**TAKELEY STREET ACTION GROUP (TSAG)**  
FORMAL PLANNING REPRESENTATION

## **TRANSPORT & HIGHWAYS OBJECTION**

Planning Application: Land North of Taylors Farm

Application Reference: UTT/25/2786/OP

## 2. Review of Proposed Access Arrangements

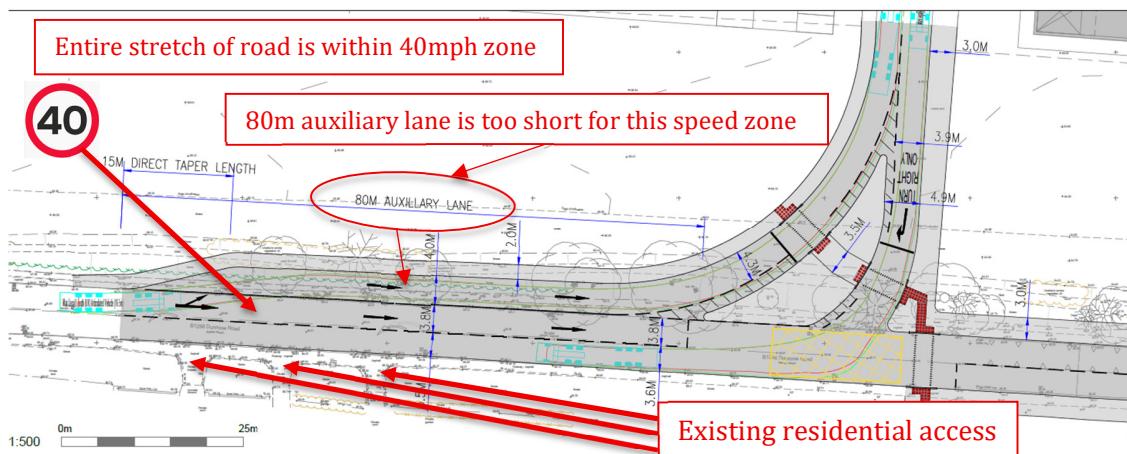
#### 1. Auxiliary Taper Lane too short.

While 80m may meet the CD123 minimum for an auxiliary lane, the applicant has not demonstrated that it provides sufficient reservoir storage for peak left-turn HGV demand under the proposed signal operation. With the proposed number of HGV movements/day, an 80m lane typically stores only ~4–5 HGVs; without junction modelling outputs showing maximum left-turn queues and spillback risk, the adequacy of the 80m length remains unproven.

No Stage 1 Road Safety Audit has been submitted despite access being the only detailed matter for approval, especially to demonstrate that this design is safe for HGV volumes anticipated by a B2/B8 enabled site. Under DMRB GG119 a Stage 1 RSA is required at preliminary design stage before access is granted. Without it, the safety of the junction, visibility splays, HGV movements and collision risk have not been evidenced. Approval of access without an RSA would be premature and potentially unsafe.

#### 2. Proposed site access traffic signals too close to Thremhall Park traffic signals.

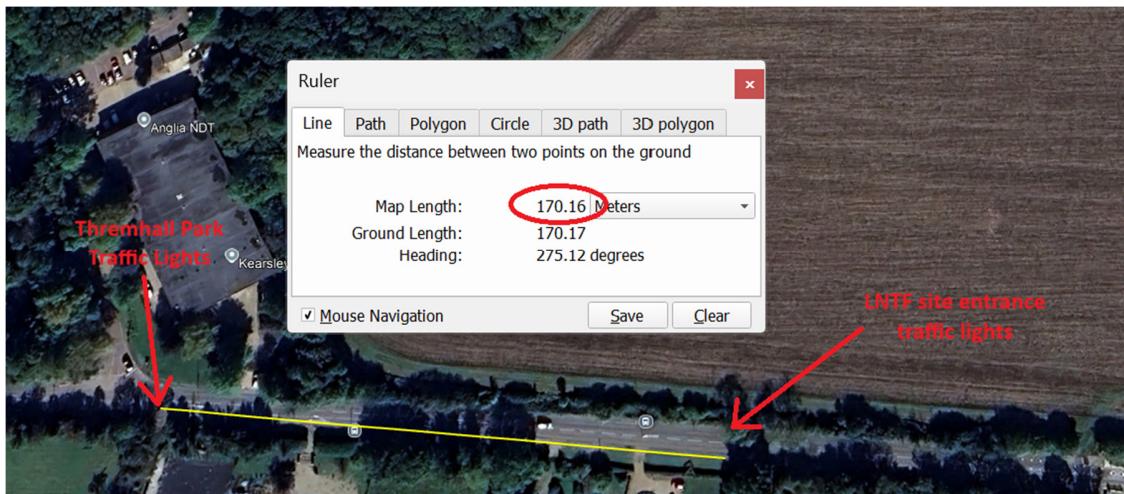
The proposed LNTF site access signals are only 170m from the next signalised junction at Thremhall Park. For a 40mph HGV route this falls below typical design guidance where spacing of 200m+ is generally required to prevent queue overlap, blocking back and conflict between junctions. No VISSIM microsimulation has been provided to demonstrate coordinated operation or confirm that queues will not interact. Without proof that both junctions can operate safely and efficiently together, the access layout cannot be considered safe or compliant with NPPF Para 116.

### 3. Lack of Bus tracking diagram via the Emergency/Secondary access point.

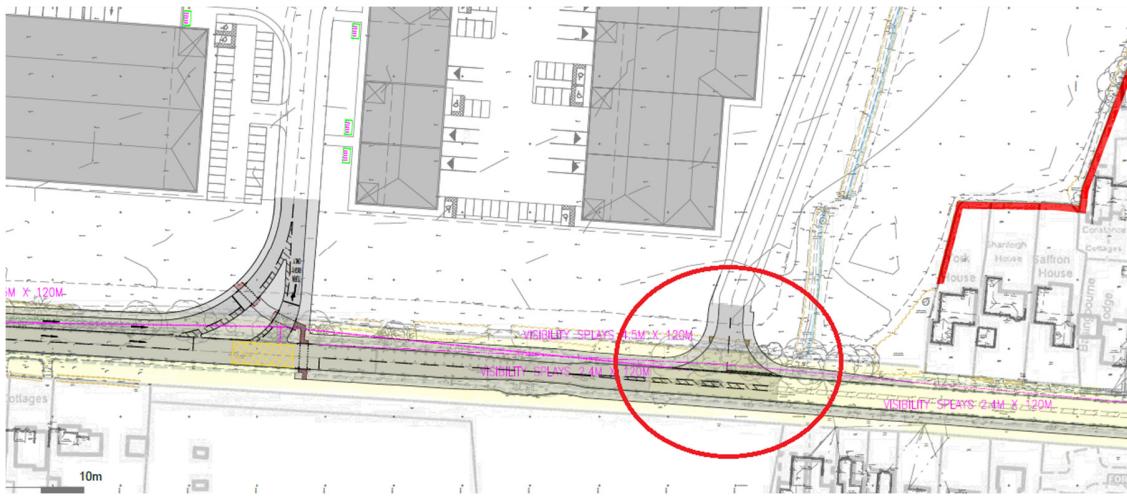
Although the Framework Travel Plan references discussions with bus operators regarding routing through the site, no swept-path analysis or geometric evidence has been provided demonstrating that a full-size bus can enter and exit safely without overrunning the centerline or opposing lane. Without bus tracking diagrams, the deliverability of the claimed internal bus routing and emergency access strategy remains unproven.

#### 4. Non-enforceable right turn only exit

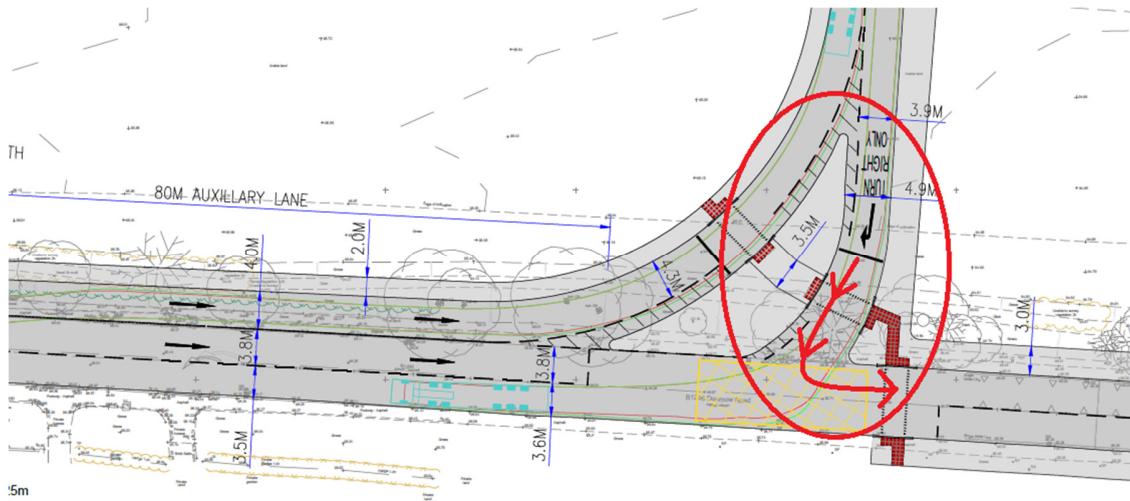
The proposed right-turn only exit is controlled only by signage and road marking, with no physical design preventing left-turn movements. Such non-physical restrictions are not enforceable and are routinely ignored by drivers. The Transport Assessment assumes full compliance with right-turn-only routing, yet the design provides no actual mechanism to ensure this behaviour. In reality a proportion of vehicles — particularly cars, vans and LGV's will turn left, altering distribution flows and invalidating the traffic modelling assumptions.

#### 5. No verge or buffer between road and pavement.

The diagram above provides no verge or buffer between the carriageway and pedestrian route. Best practice typically seeks ~1.5m separation (or robust physical segregation) where HGV movements occur, yet the proposal runs pedestrian/cycle space directly against

the carriageway. This creates a high-risk interface with heavy goods vehicles with no recovery space, contrary to MfS and principles of CD143 safe separation.

Pedestrians walking right beside HGV traffic — no safety buffer provided. School children waiting for buses within 80cm of 44-tonne lorries.

## **6. No ghost-island right-turn lane is provided for the secondary access.**

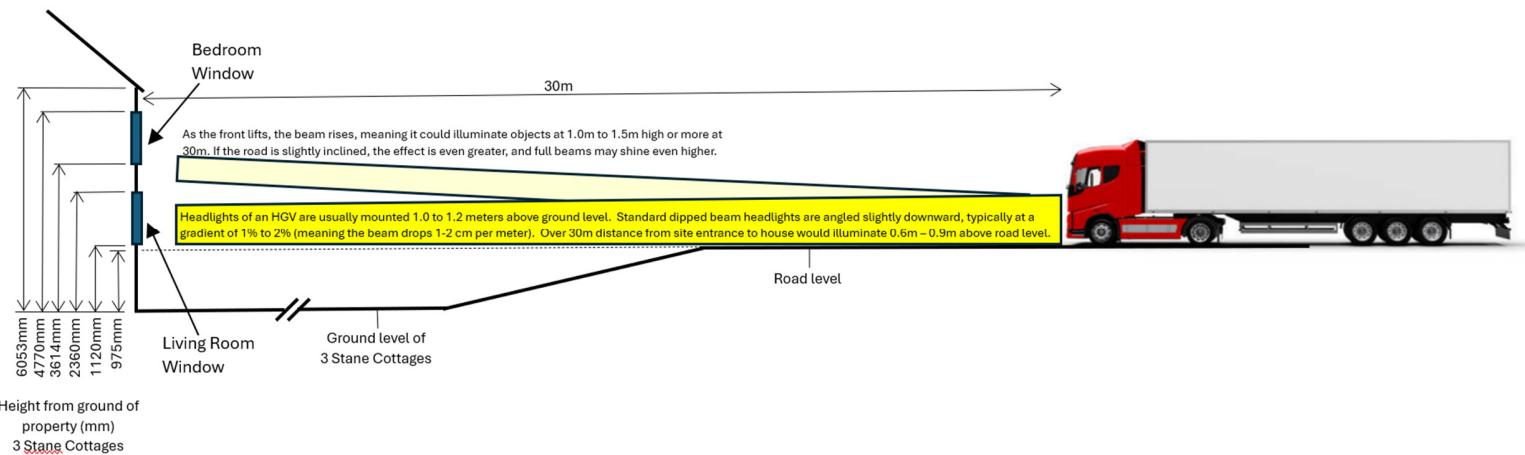
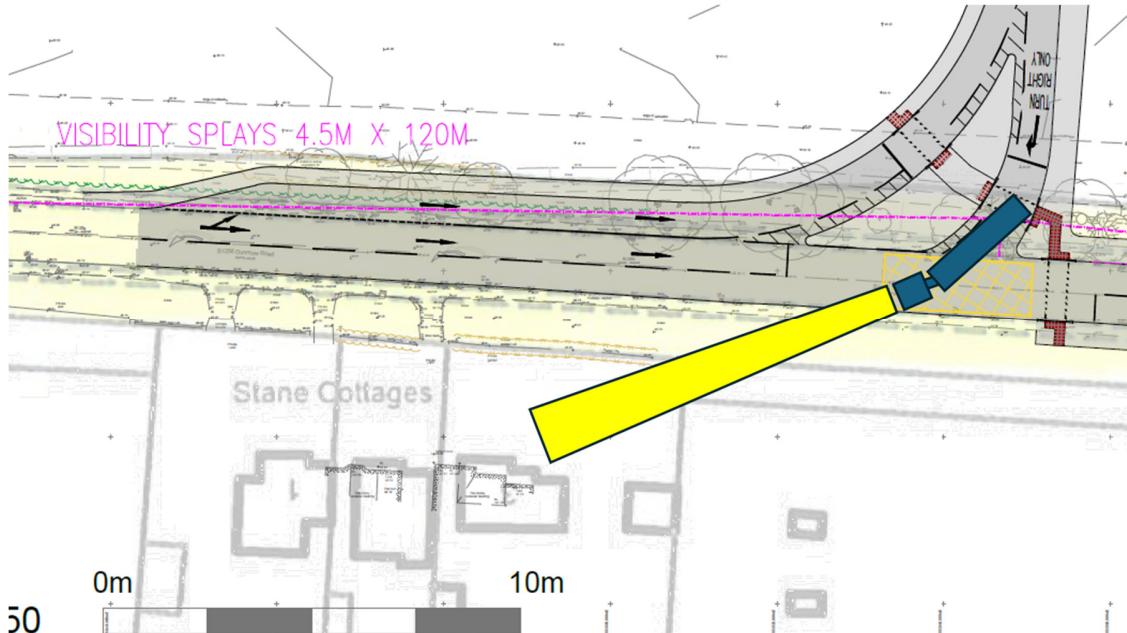
Even if HGVs are excluded, right-turn movements by cars and buses will stop in the running lane, causing queueing and rear-end shunt risk. DMRB turning-lane standards expect a protected right-turn pocket unless turning movements are extremely low and proven. No evidence has been provided to justify omitting a ghost-island or deceleration lane.

**Figure 4 – Consented M11 Junction 8 Improvement**

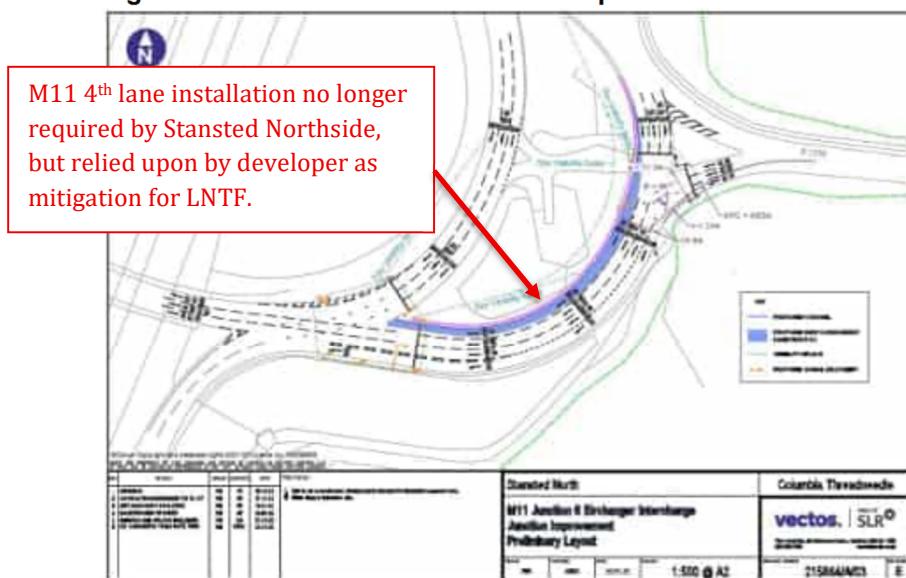
**1. Northside's submitted S106 variation (UTT/25/2814/DOV) confirms they will not deliver the fourth lane at M11 J8.**

Page 64 of the new Stansted Northside Transport Assessment (below) found within UTT/25/2814/DOV specifies the TA seeks to demonstrate that the full scheme is no longer needed.

**4. The Taylor's Farm (LNTF) Transport Assessment still relies on the additional capacity from the fourth lane as shown in Appendix J of their TA, that is now subject to a separate application seeking its removal.**

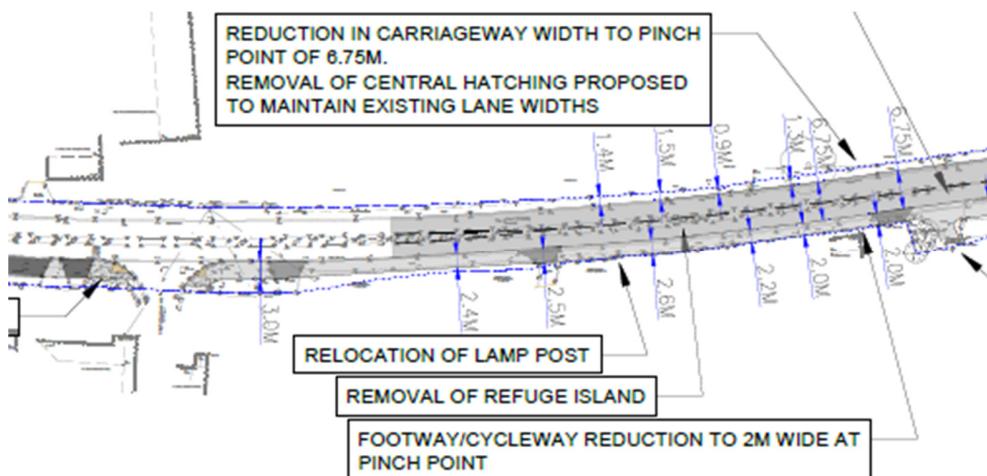
- The proposal reduces part of the B1256 from 7.3m to 6.75m adjacent to cycle lane.
- The B1256 carries 9,000–12,000 vehicles/day, including HGVs and buses.
- 6.75m is insufficient for safe opposing HGV movements without close-pass risk.
- LTN 1/20 states that higher-risk environments require greater buffer and width, not less.
- Reliance on a future / uncommitted 30mph reduction is not a safety guarantee. The narrowing creates and increased collision risk.

- The proposed narrowing extends for around 120 metres — far beyond what could be considered a brief or “extremely short” constraint. LTN 1/20 only permits sub-standard widths in very short, unavoidable pinch points, not sustained lengths running adjacent to a heavily trafficked and hazardous road (B1256)
- LTN 1/20 requires pinch points to be minimal in length and only at unavoidable features.
- This design creates extended substandard width, rendering the route non-compliant.

The diagram below shows the proposed narrowing to 6.75m for the carriageway with a 2.0m cycle lane (total width 8.75m) forcing HGVs, buses and cyclists into close proximity. **This design is unsafe and risks becoming a collision hotspot.**

Diagram proving end of cycle way is purely due to constraints of highway (houses within 1m of roadside).

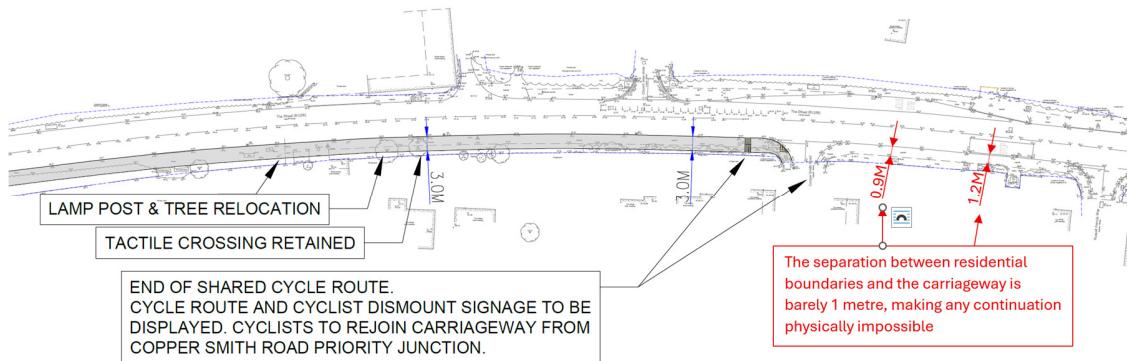
- The route ends by forcing cyclists back into the B1256 near a known congestion hotspot.
- Junction modelling predicts delays and queues — a high-risk re-entry point.
- LTN 1/20 requires coherent, continuous routes without abrupt termination.

Diagram showing small stretch of proposed cycle lane with continuous driveway collision interfaces.

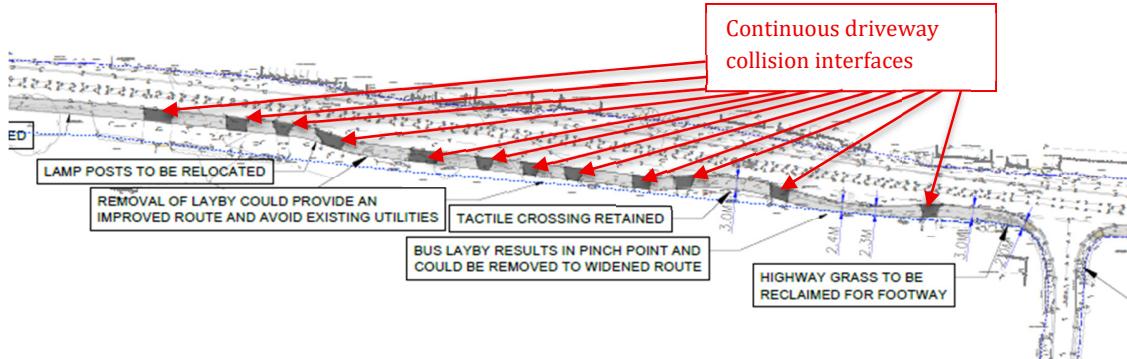
- 38 driveway crossings + 5 side roads over 2.2km  $\approx$  a conflict every  $\sim 51m$ .
- Each crossing point represents a potential vehicle-cycle conflict.
- LTN 1/20 expects low-conflict design, not continuous interaction points.
- High collision exposure.

## 14. Cycle Lane Requires Removal of Resident Parking Bays — No Impact Assessment Provided

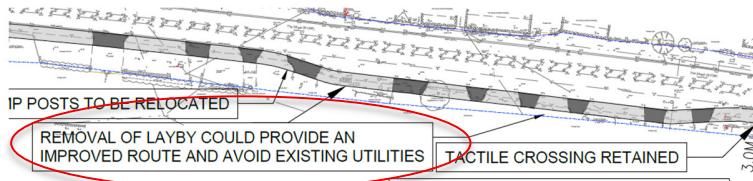
The TA discussed the removal of the B1256 layby to deliver a shared-use cycleway. However, this layby has recently been converted into Resident Permit Parking and forms an active part of local parking provision. The TA does not assess loss of resident bays, parking stress impact, displacement onto side roads, or alternative provision.
